15-000854

## Service Provider Letter

Woodhaven Park Improvements

PROPOSED DEVELOPMENT  
**WOODHAVEN PARK**  
 BEAVERTON, OREGON

SPL ATTACHMENT 1 OF 1

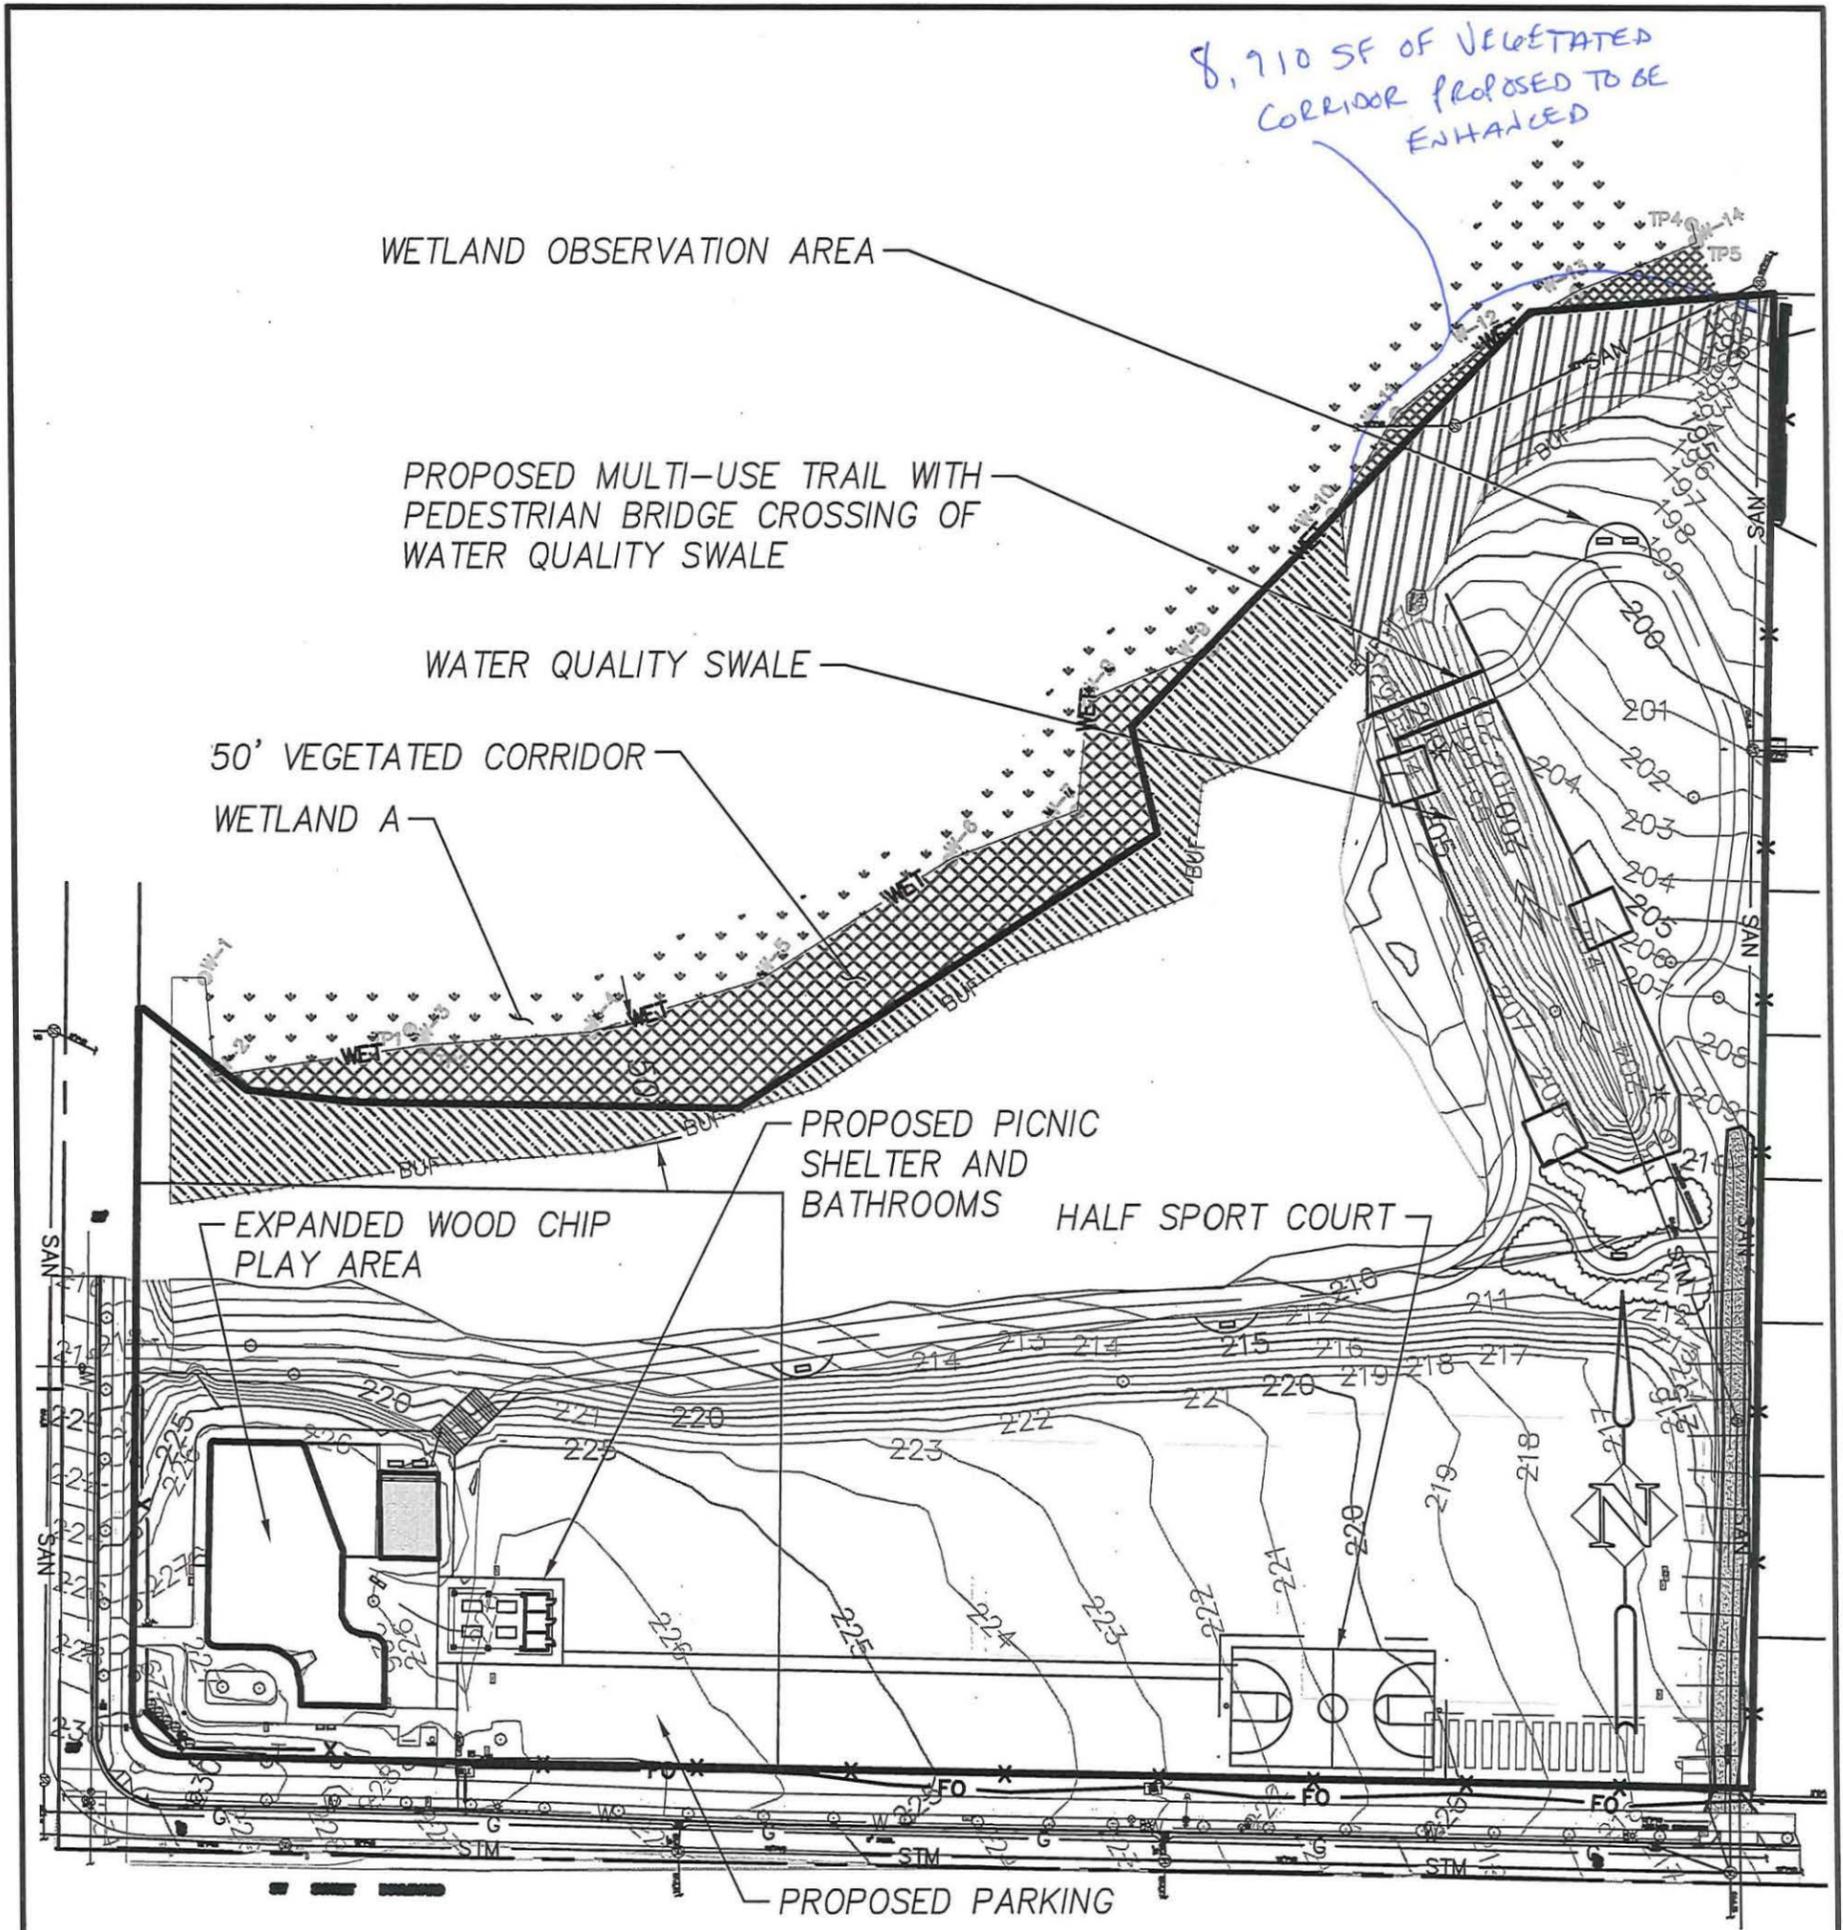
10. **Should final development plans differ significantly from those submitted for review by Clean Water Services, the applicant shall provide updated drawings, and if necessary, obtain a revised Service Provider Letter.**

23. **Final construction plans shall clearly depict the location and dimensions of the sensitive area and the Vegetated Corridor** (indicating good, marginal, or degraded condition). Sensitive area boundaries shall be marked in the field.
